Herron Design Studio

August 03, 2026

In response to your printed comments, dated July 15, 2026, I am submitting this document and others for consideration by the HPC at their September meeting seeking approval for the site elements noted during your inspection and listed in your review.

ZIGGI'S  CAFE

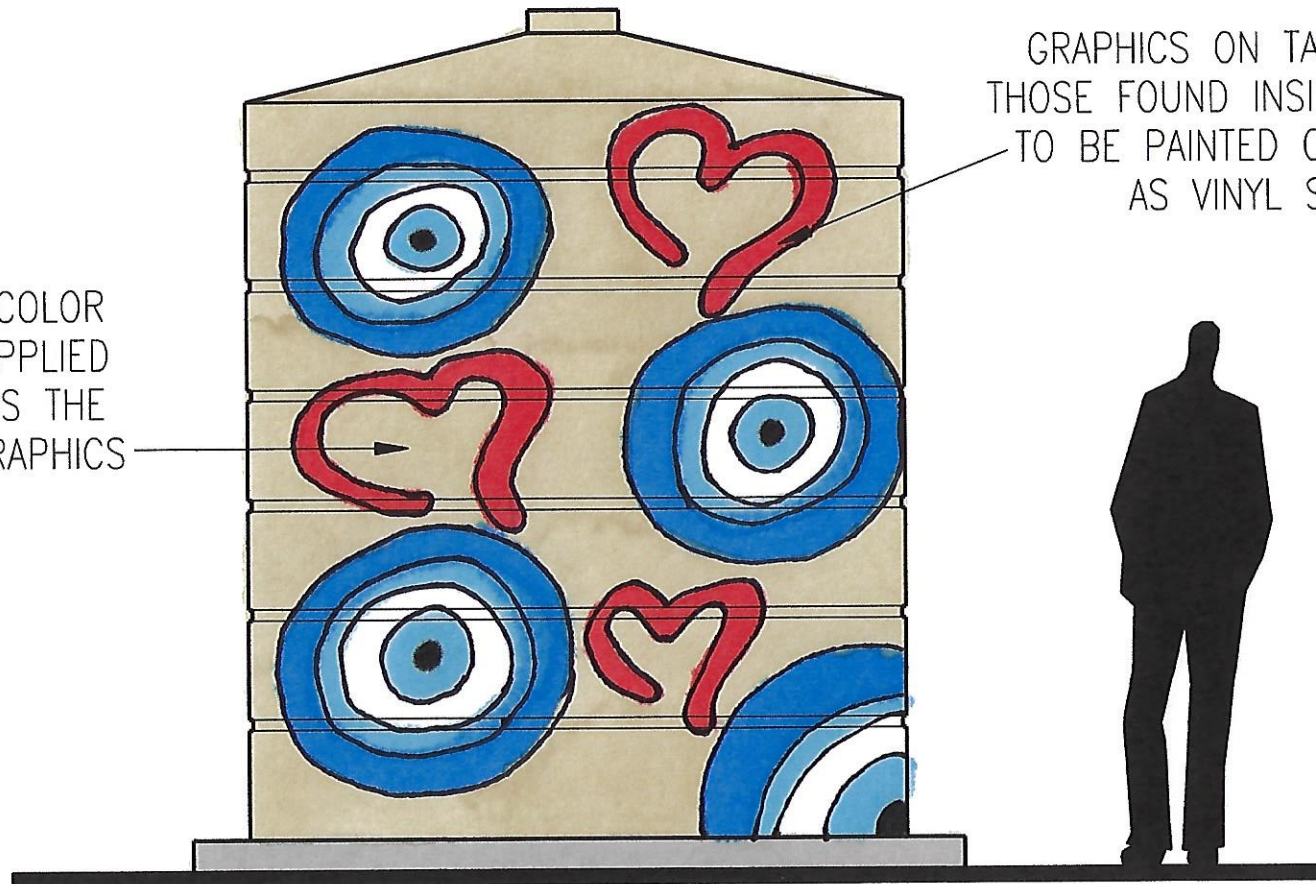
The color sketch of the proposed graphics to be applied to the rain-water collection tank on the east side of the building fronting Ranch Road 12 is an exterior extension of the graphics painted on the interior walls of the Café. They will be either painted on or applied to the tank with high-performance vinyl stickers whichever is deemed to have more weather and sunlight resistance and last the longest. We are requesting approval for the graphics, however we would also like approval for the latitude for when the graphics are to be applied to the tank. We truly believe that the trees and bushes planted on that side of the building in the landscape bed in combination with the 6 foot tall privacy fence on the north property line will effectively screen the tan colored tank from being a visual distraction from either an aesthetic or driving safety standpoint. The photos in the submittal show this well, I feel. The tank graphics are certainly fun and may bring attention to the tank and the Café that would outweigh the cost of execution but we feel being mandated to install them within a specific time-frame is not warranted considering the tank was approved as-is in the Site Development Permit process and the landscape will considerably screen the tank from view.

TAN/LIGHT BROWN COLOR
OF TANK IS MFR. APPLIED
AND WILL REMAIN AS THE
BASE COLOR FOR GRAPHICS
APPLICATION

GRAPHICS ON TANK TO MATCH
THOSE FOUND INSIDE ZIGGI'S CAFE
TO BE PAINTED ON OR APPLIED
AS VINYL STICKERS

7'-3" DIAMETER FIBERGLASS
RAIN-WATER COLLECTION TANK
ON 4" H. CONCRETE PAD
